12/16/2024
CAL FTL 54-035

Subject: Enabling Virtual Regen Request Switch in ICU Menu

Make: Freightliner

Model: M2 plus, 108SD Plus/114SD Plus

Fig. 1 Disabled Manual Regen Virtual Switch

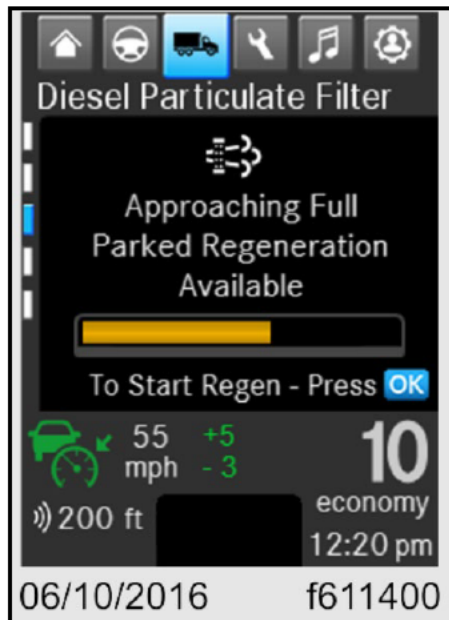
M2 Plus and SD Plus vehicles built from May 9, 2023, through March 28, 2024, and equipped with a Cummins engine may experience an issue where the virtual regen request switch is not enabled in the ICUC, preventing the driver from manually requesting a regeneration. See [Fig. 1](#) and [Fig. 2](#). Refer to Freightliner publication [TSB 54-371](#) for instructions to update the ICUC.
